Installation of Updated Defrost Grille, Canada

Classification	Repair Bulletin	Section/Group	14 - Instrument Panel & Pedals	Country/Region	Canada
Year	2012-2013	Model	Model S	Version	All

This Service Bulletin supersedes SB-13-14-005 R1, dated 22-Jan-2014. Each content change is marked by a vertical line in the left margin. Discard the previous version and replace it with this one.

Figure 1

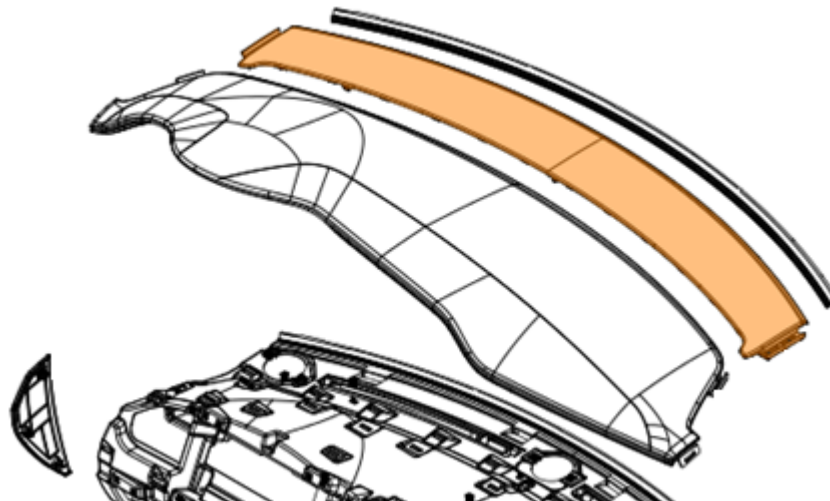
Some vehicles were shipped to Canada with the standard version of the defrost mesh grille. Although this grille promptly defrosts the windshield and meets all minimum Canadian Motor Vehicle Safety Standards, the updated grille improves windshield clearing performance in the edges near the LH and RH A-Pillars.

Upon customer complaint, replace the defrost mesh grille with the updated part (Figure 1).

Figure 2

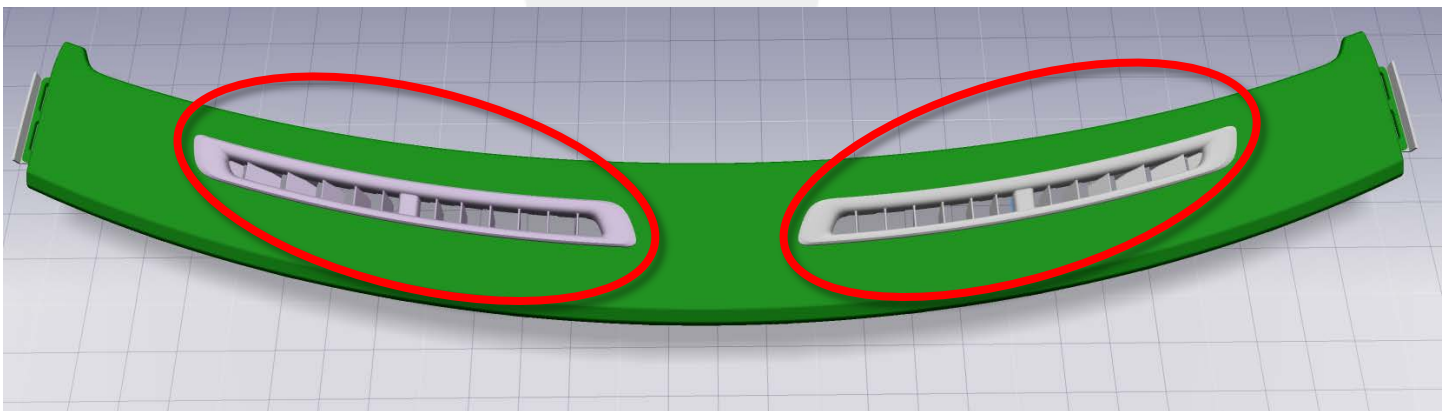
1. Inspect the defrost mesh grille that is inside the vehicle. If the grille has vents that direct air toward the A-Pillars (Figure 2), then the new grille is already installed and no more work is needed.
